Review of water quality and ecosystem health impacts of the proposed Don Sahong Hydropower Project –
A contribution to the Prior Consultation Process.

Final report

For Water Quality and Ecosystem Health Expert Group

10/12/2014

Figure 2: Areas of the Hou Sahong to be excavated to increase flows to DSHP and in the Hou Xang Pheuk to enhance fish migration and for the flood flows spillway

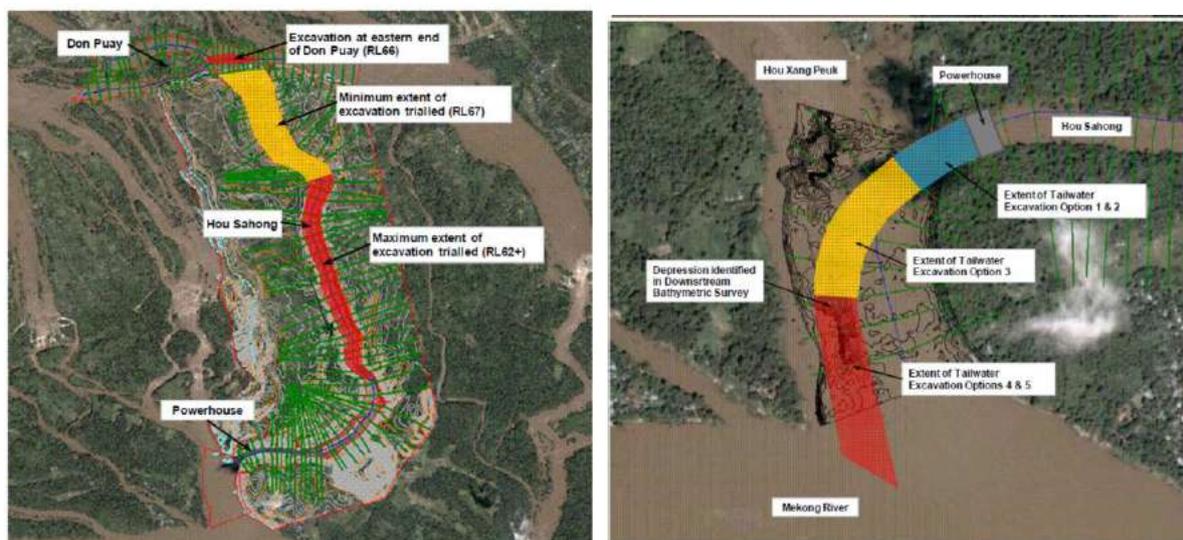
- There is no consideration of the impacts of the channel modifications in the Hou Sadam and Hou Xang Pheuak upon water quality and measures to prevent excess sediment being released into the water in the dry season when these works will take place.

According to the hydrological studies carried out by the DSHP, the natural flows down the Hou Sahong have an annual average of 510 m³/sec, with high flows of about 1500 m³/sec and low flows of under 50 m³/sec. The aim of the DSHP is to increase flows entering the Hou Sahong channel to maintain the design flow of 1600 m³/sec throughout the year. At present the bed levels in the upper reaches of the Hou Sahong restrict this level of flow into the channel during periods of low flow, and in order to improve the flow through the DSHP the river bed at the upstream end would be excavated and lowered to an average depth of 3m and a maximum depth of 5m, and by 1.5 m at the lower end of the channel. A limited area will be excavated downstream of the powerhouse.

It is stated that excavated materials will be used as concrete aggregate and for the embankments, and that any blasting and excavation will be undertaken after the coffer dams are in place, so that erosion and sediment release into the river are minimised. A total volume of material to be excavated in the Hou Sahong is estimated at 2.4 million m³ and 72,000 m³ in the area downstream of the power house.

Figure 4: Schematic diagram of channels in the Project vicinity

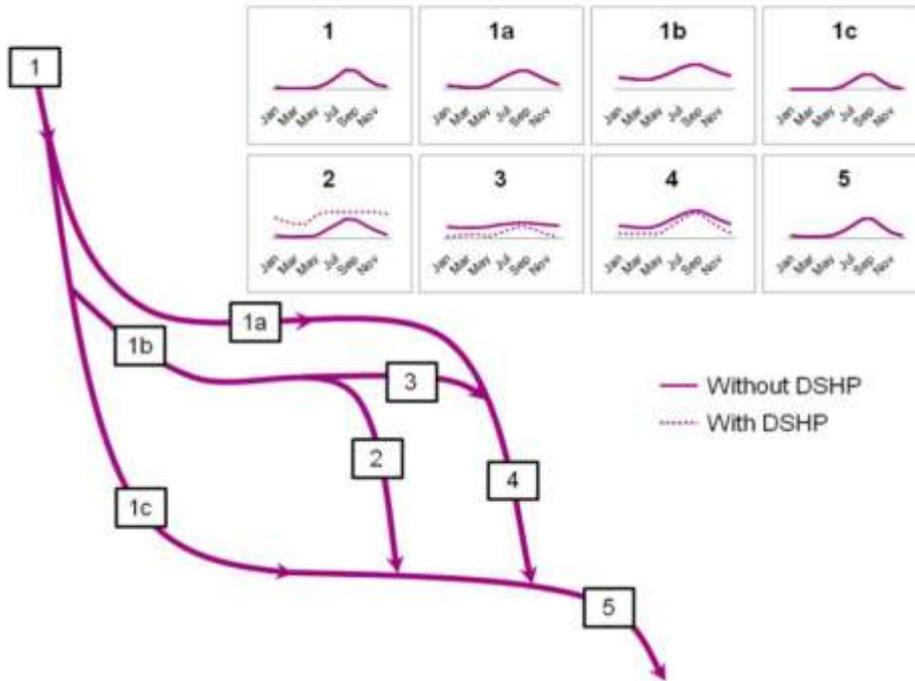
Figure 3 shows a schematic of the modelled flows down the different channels across Siphandone and Tables 7 and 8 show the results of the modelling showing the average monthly flows across these channels.

1. Mean monthly flows in channels 1 and 5 are the same, indicating that flows into the system and out again are the identical and there is no change in flow between upstream and downstream with the season.
2. The flows in channels 1a, 1b and 1c i.e. on the west side do not change, but flows down the Hou Sahong (channel 2) increase from an average of 510 to 1500 m³/sec, with high flows of 1750 m³/sec being maintained for between 40 - 50% of the year.
3. The flows down channel 4 decrease from an average of 2880 to 1880 m³/sec with minimum flows of 800 m³/sec being maintained for 40 - 50% of the year.

Note that the blue lines indicate channels in which the flows are not expected to change, and pink lines indicate the channels where changes in flows are expected.

Figure 5: Changes in average monthly flows down the Hou Sahong and over Khone Phapheng Falls as a result of DSHPP

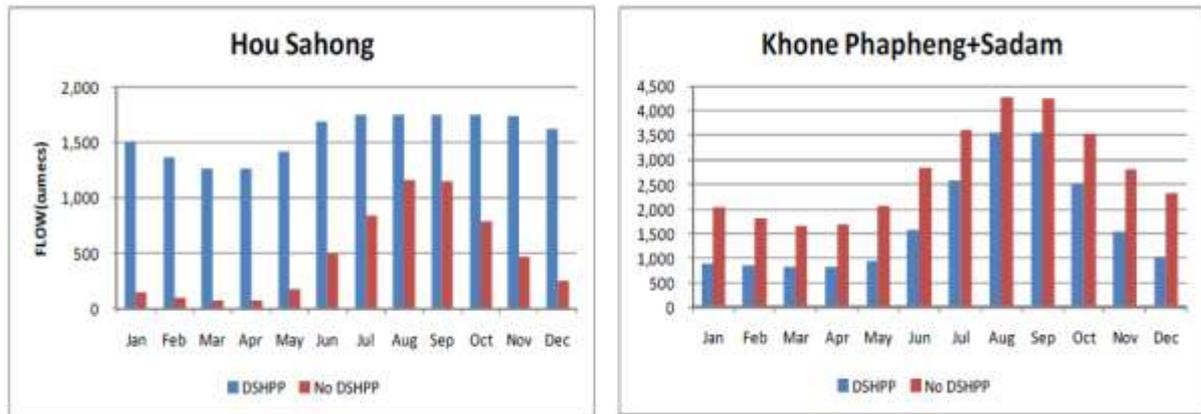
Figure 5 – 10 show comparisons of the average, minimum and maximum monthly flows down the Hou Sahong and Khone Phapheng channels. The following points can be noted

- In a wet year, flows in the Hou Sahong are maintained above 1500 m³/sec throughout the year, while the flows over the Falls are lower than 1000 m³/sec for February, March and April. In the wet season of a wet year there is little difference in the flows with or without the DSHPP.

Figure 8: Changes in flow at different locations in the Mekong mainstream downstream of DSHPP

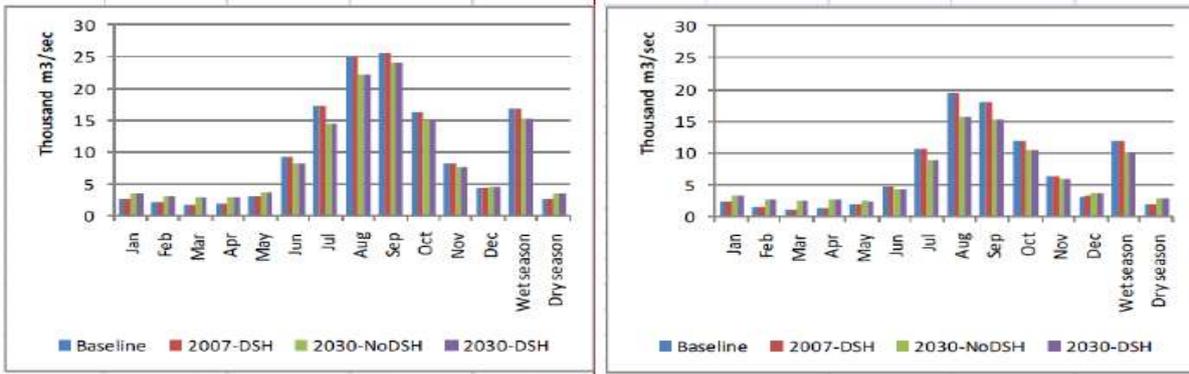
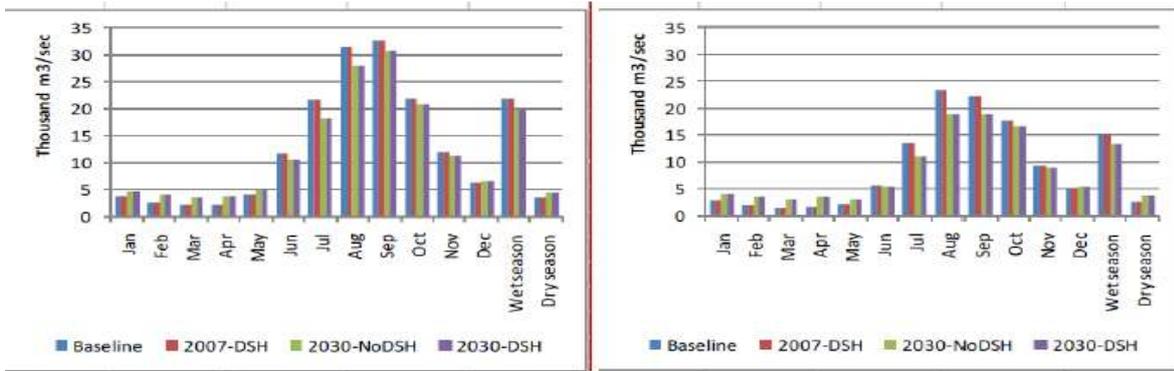
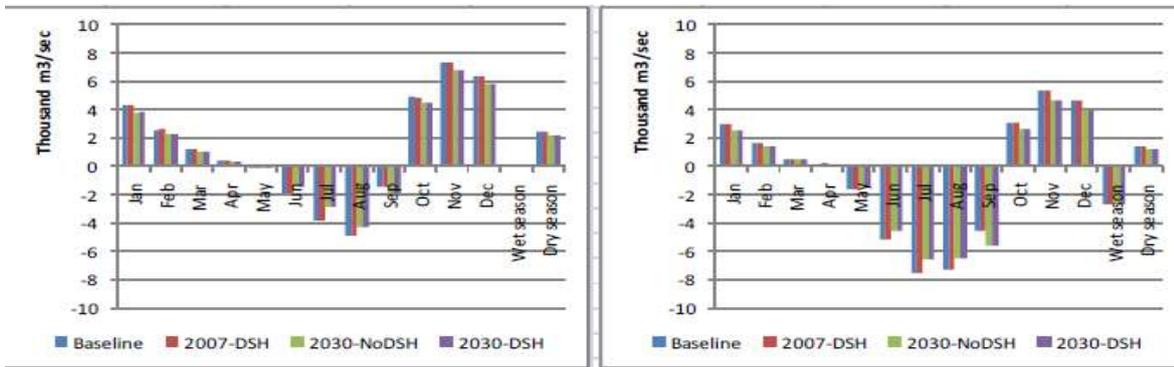
The wider transboundary changes in flow in Cambodia and Vietnam are considered in the Cumulative Impact Assessment report of DSHPP. The results from the modelling exercises for both average flows and dry year flows are shown in the diagrams excerpted from the CIA report (Figure 11). This covers immediately downstream at the Lao Cambodia border, at Kratie, at Prek Dam on the Tonle Sap. These figures also include the projected changed flows with the development of hydropower projects upstream by 2030.

These figures show that there is virtually no difference when the baseline is compared to the modelled results with the DSHPP in 2007. Similarly there is no difference between the monthly flows in 2030 with and without the DSHPP in any of the three flow positions considered. There is however, a significant difference in the flows projected for 2030 because of the influence of storage dams in the upper tributaries of Mekong; wet season flows are decreased as water is stored at times of higher flow, and dry season flows are increased as a higher discharges are released from the storage dams. Nevertheless, there are very little differences in flow with and without the DSHPP in 2030 at any of the three sites. This is to be expected since the DSHPP is a run-of-river dam with 1 – 2 hours of storage. There may be a very small lag in the flows passed downstream, but this is unobservable in average monthly flows. All the channels in this braided section of the Mekong come together into a single channel about 8 km downstream from the border as shown in Figure 8.
